**Re: Supplemental Submission Package
Proposed GMP Lab Facility
298 Concord Road
Billerica, MA**

STORMWATER RESPONSE TO COMMENTS

**Re: Proposed GMP Facility
298 Concord Road
Billerica, MA**

Below please find our responses to BETA Group, Inc.'s "298 Concord Road Peer Review – Stormwater" letter, dated March 6 2023. For clarity, the peer review comments are in standard font type, while our responses are directly below in ***bold italic text***. Supplemental materials in support of these responses have been provided under separate cover, as outlined on the cover letter.

PEDESTRIAN ACCESS PLAN

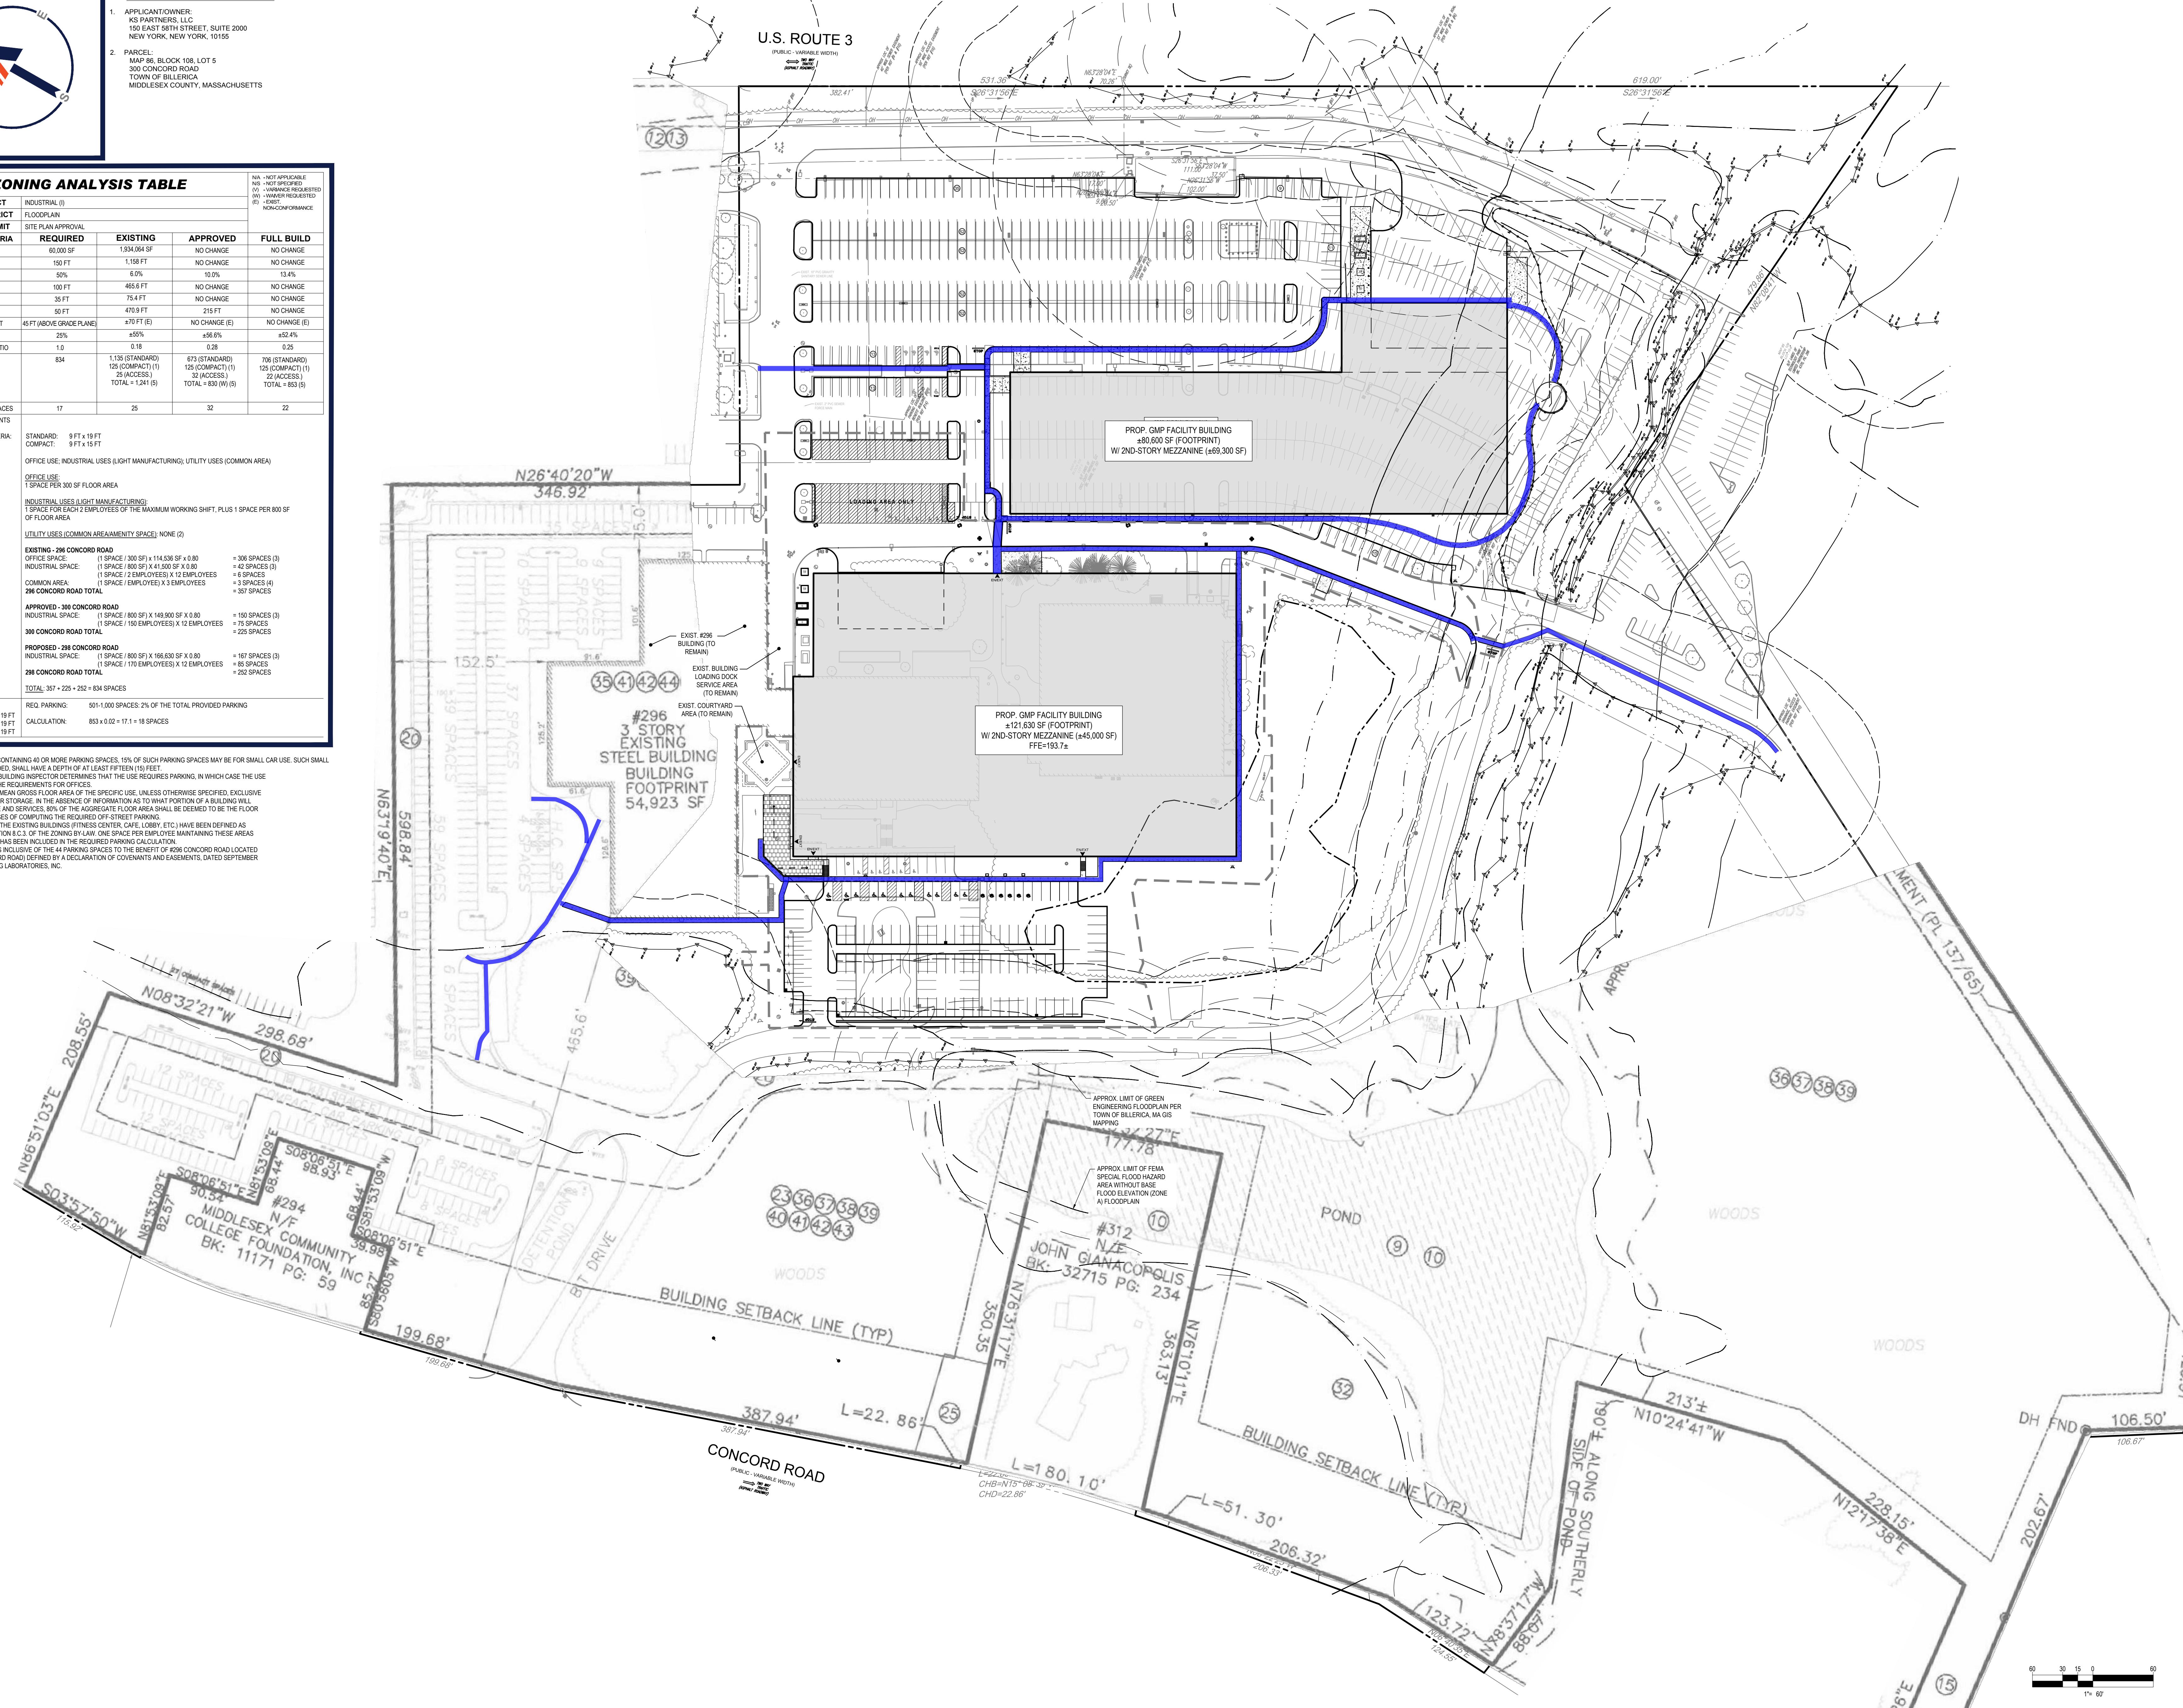
SA1. Provide an overall pedestrian access plan for the site (campus).

An overall pedestrian access plan has been provided.
